Engineering comments for Piling No. 1 & 2 have been provided in this document for 1st review.

EL PASO COUNTY PLANNING & COMMUNITY DEVELOPMENT NUMBER: ~~SF26X~~

IRON RIDGE FIGLING NO. 1 & 2

SECTION A-A  
SCALE: 1" = 3'

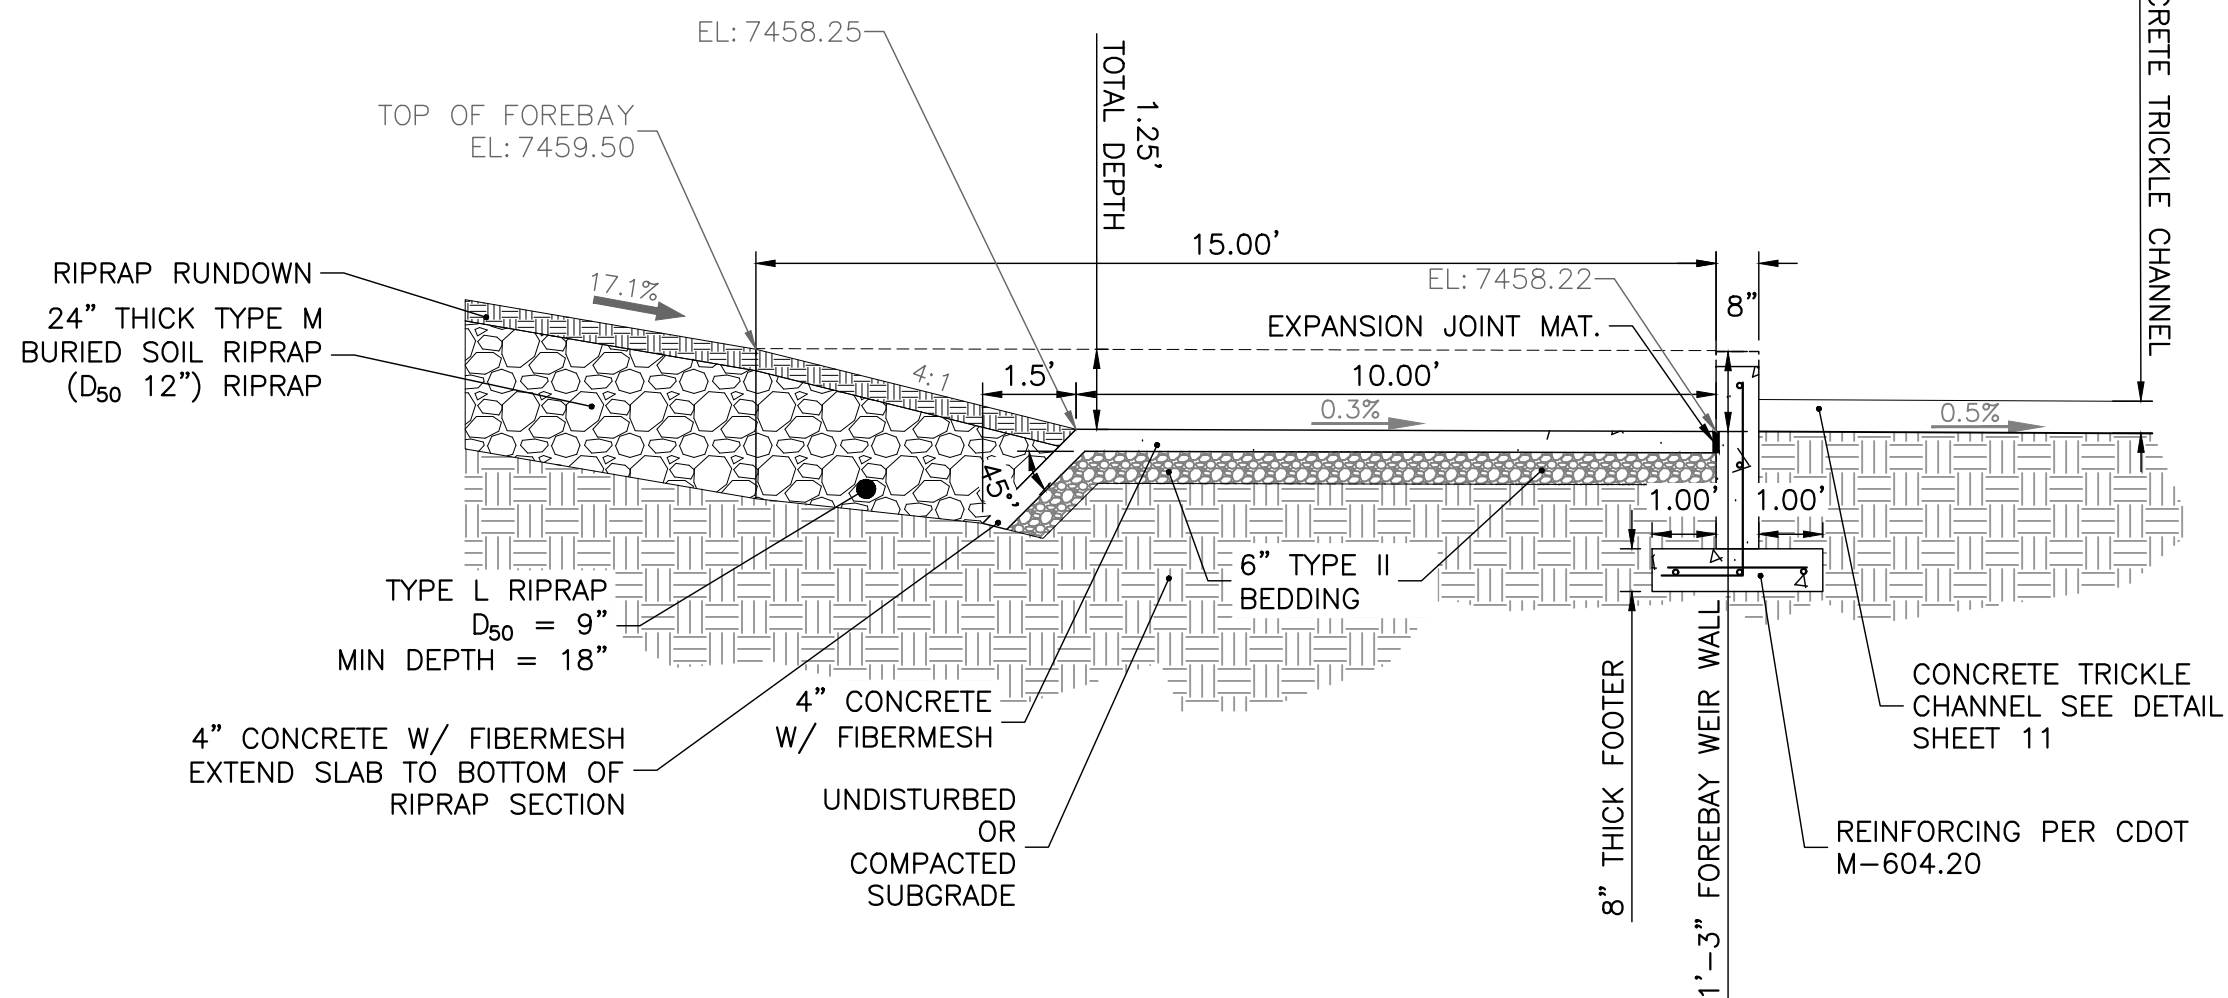
Provide specifications for riprap downstream of forebay (dimensions, riprap type and depth, soil or conventional riprap).

Provide a detail for the cutoff wall. Does the top mirror the typ swale detail?

I don't think this should apply to the forebay wall riprap because the soil riprap and vegetation are necessary to detain flows.

TOP VIEW  
SCALE: 1" = 3'

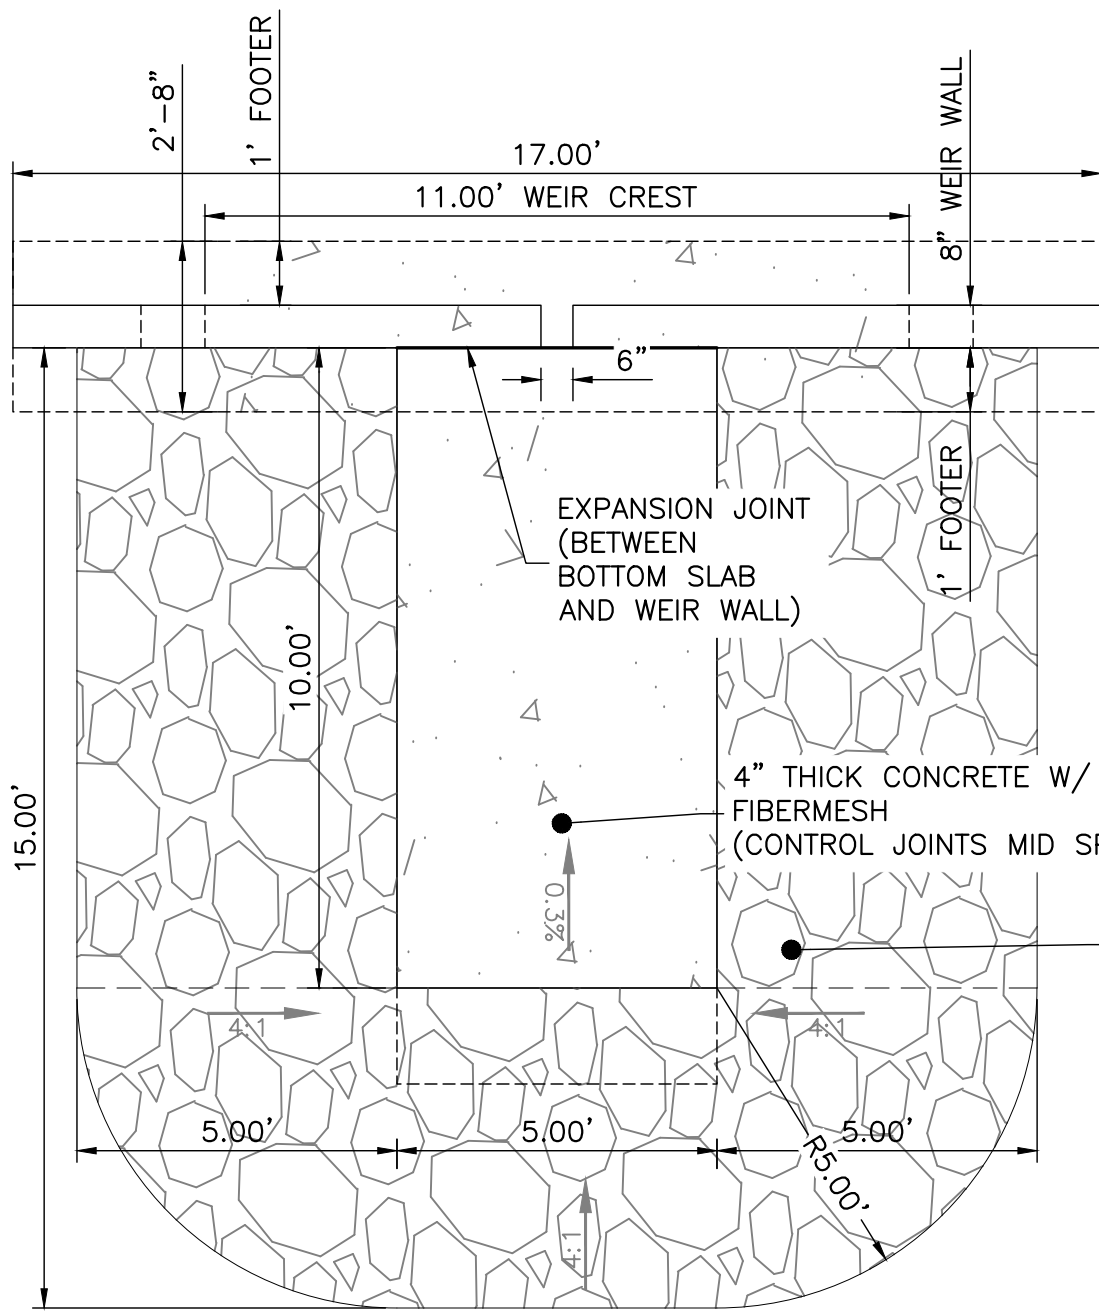
Are the forebay walls buried soil riprap? Please clarify.

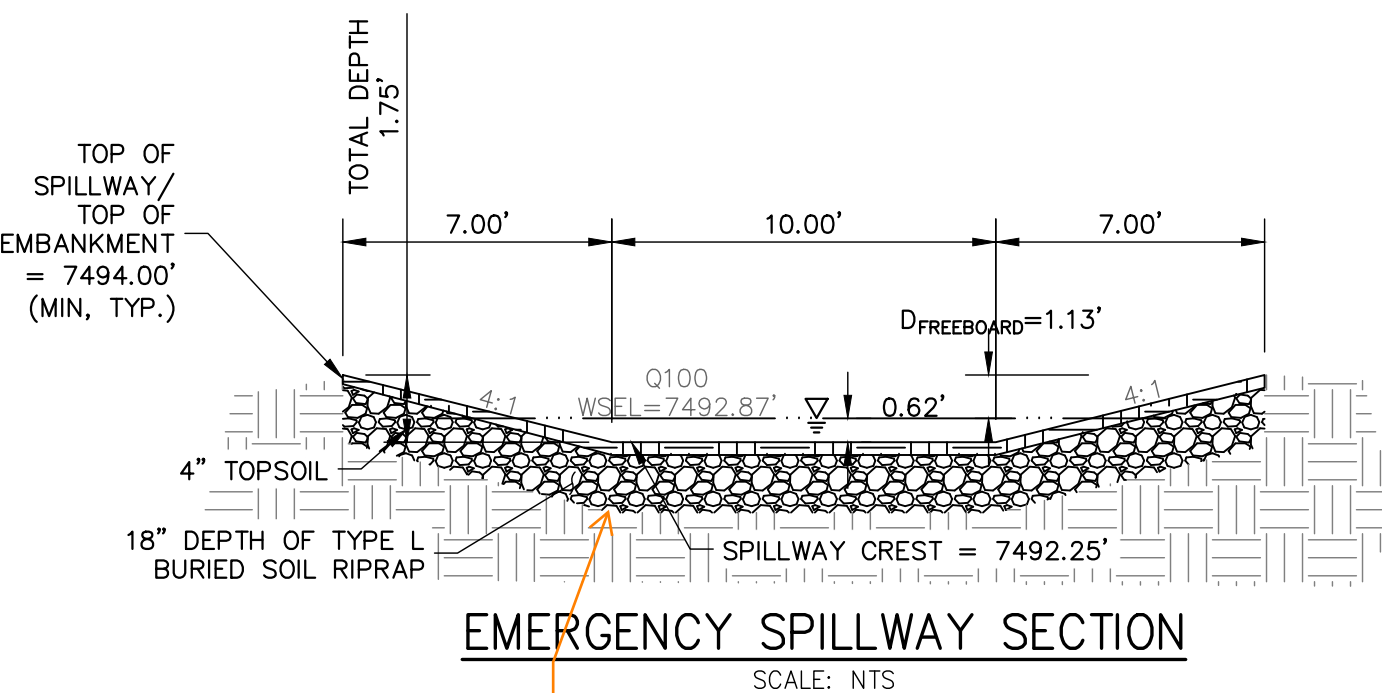
Provide bedding material/geotextile fabric between riprap and sub-base (per DCMv1 – Chap 10.10.5).

THIS SECTION DOES NOT APPLY TO SOIL RIPRAP, IT APPLIES TO PLAIN RIPRAP. SOIL RIPRAP BEDDING IS GENERALLY NOT REQUIRED OR RECOMMENDED BY MHFD.

GEC PLAN

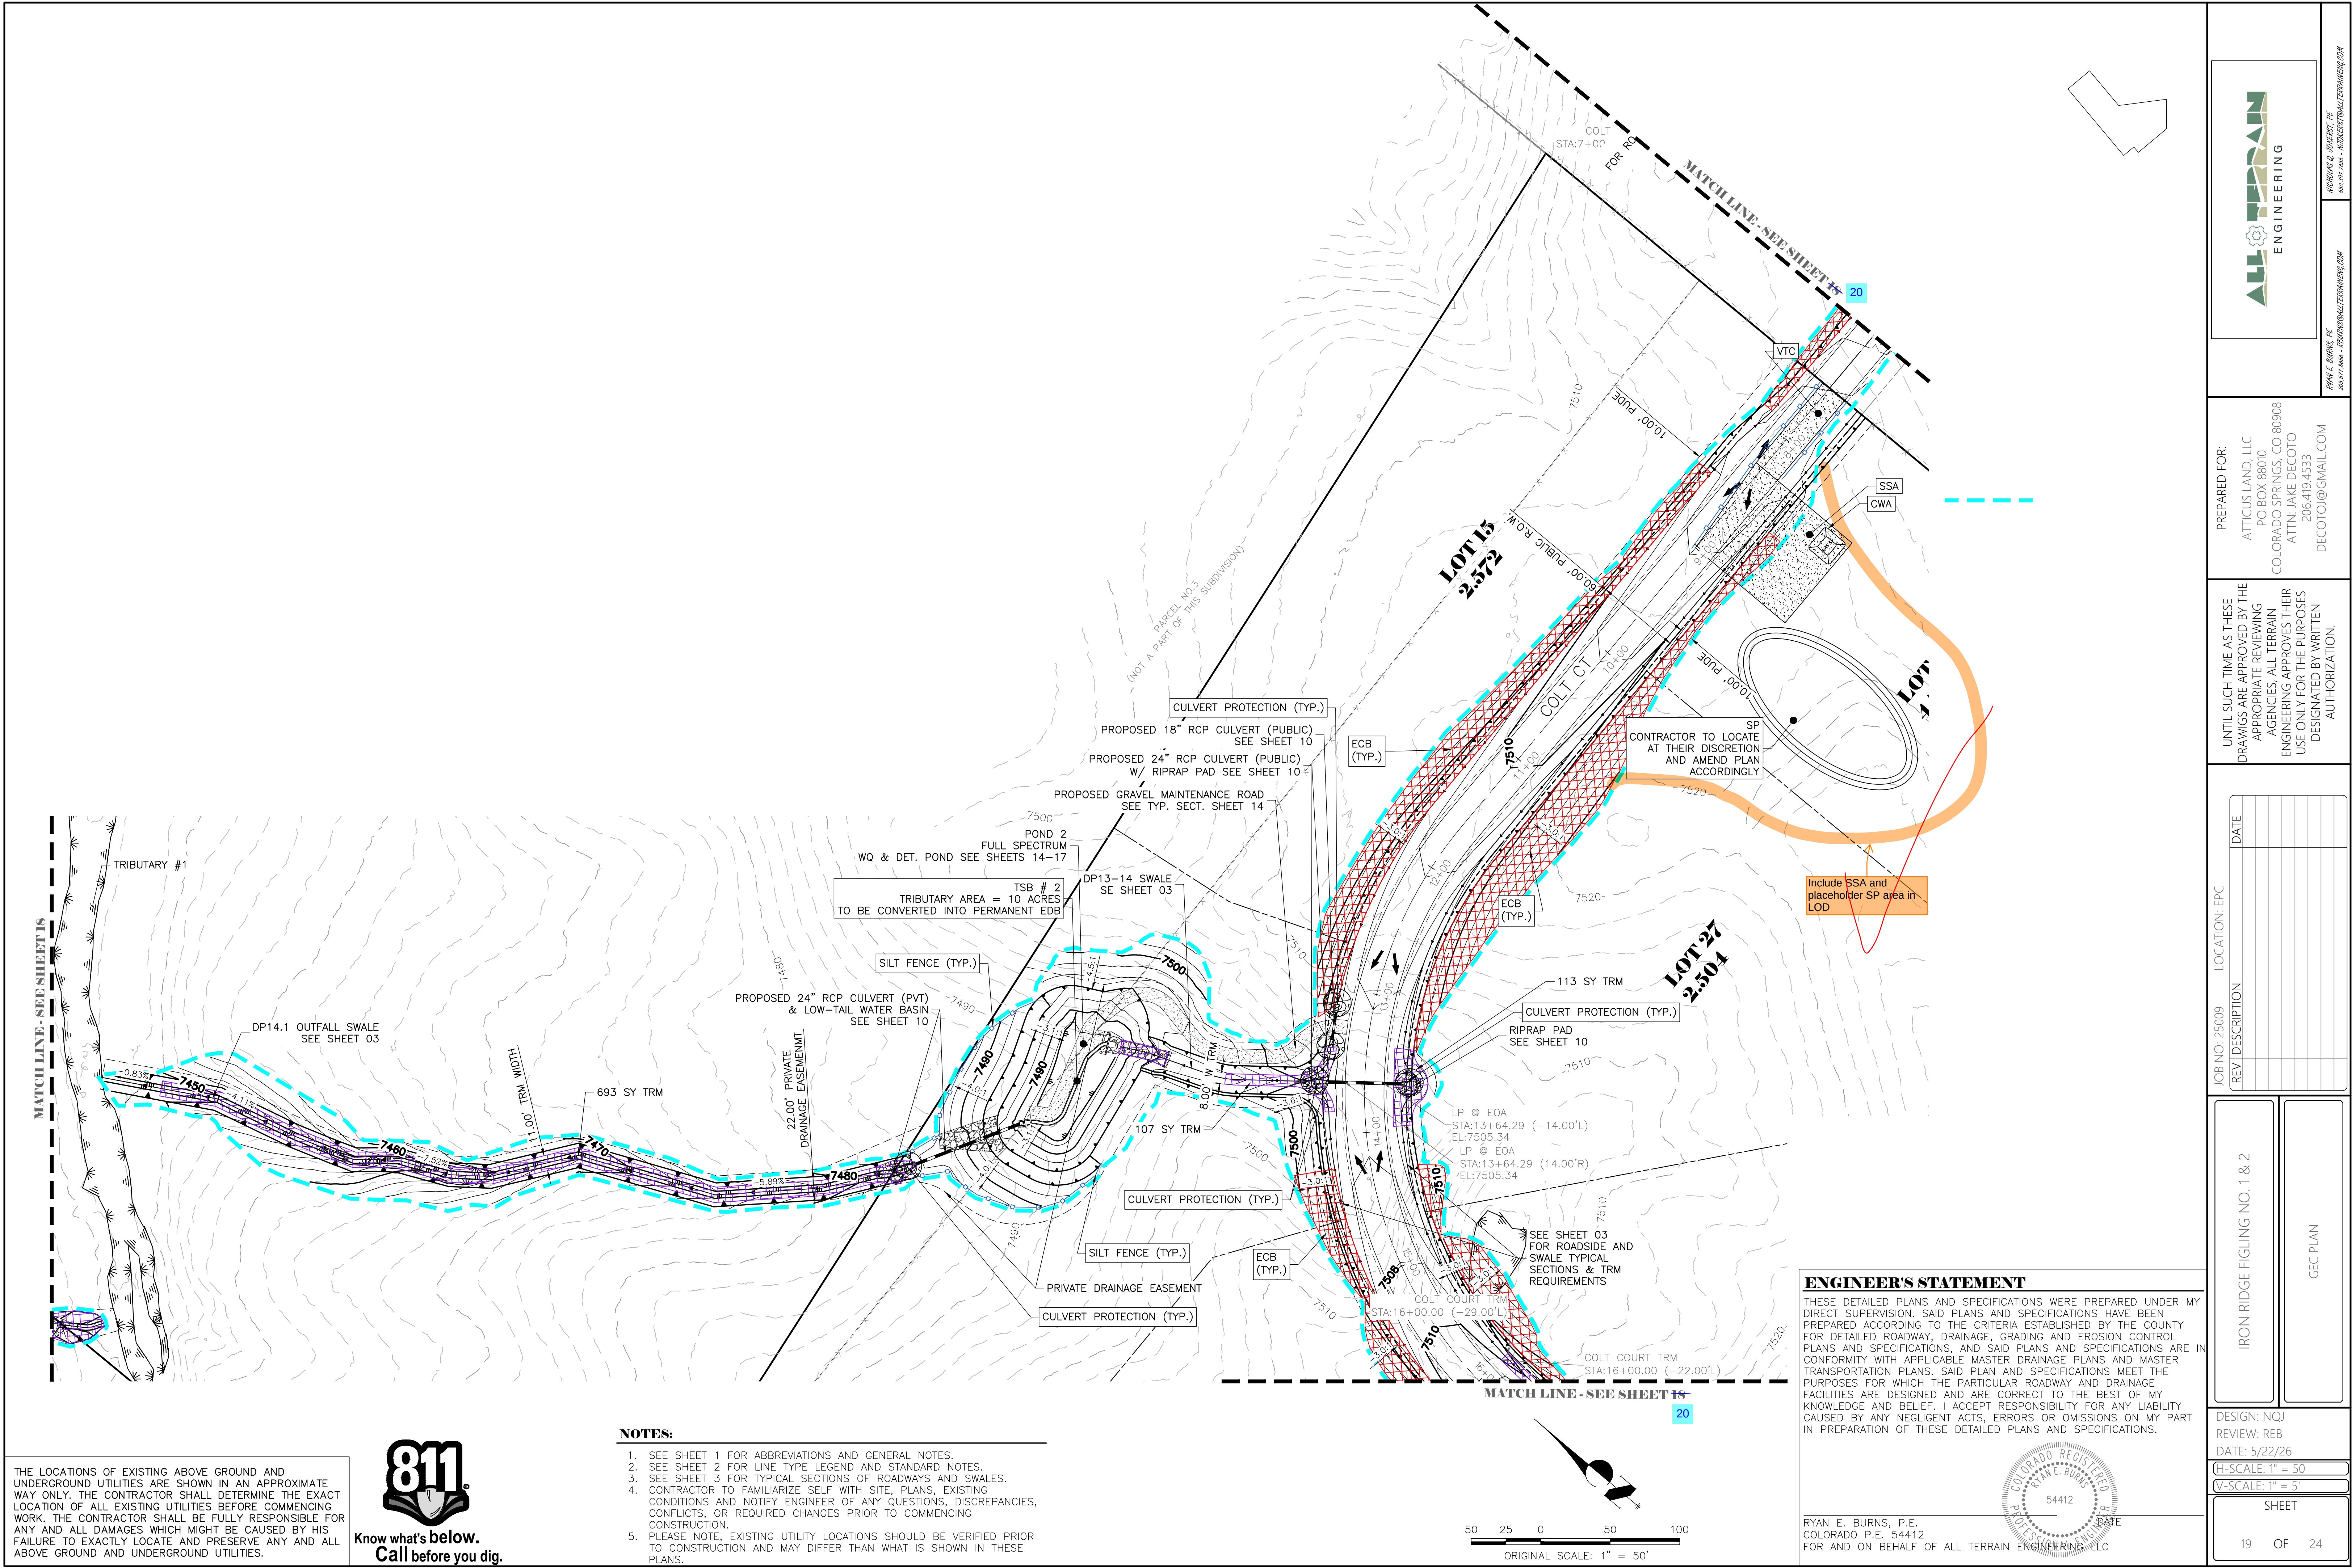
Provide a note describing the existing vegetation on the site.

Provide a phasing plan for the temporary control measures where each is identified by "initial," "interim," or "final."

Include SSA and placeholder SP area in LOD. Update disturbed area noted in ESQCP form and SWMP as necessary.

What's this line?

Show areas of cut and fill  
Provide flow flow direction arrows on and off-site
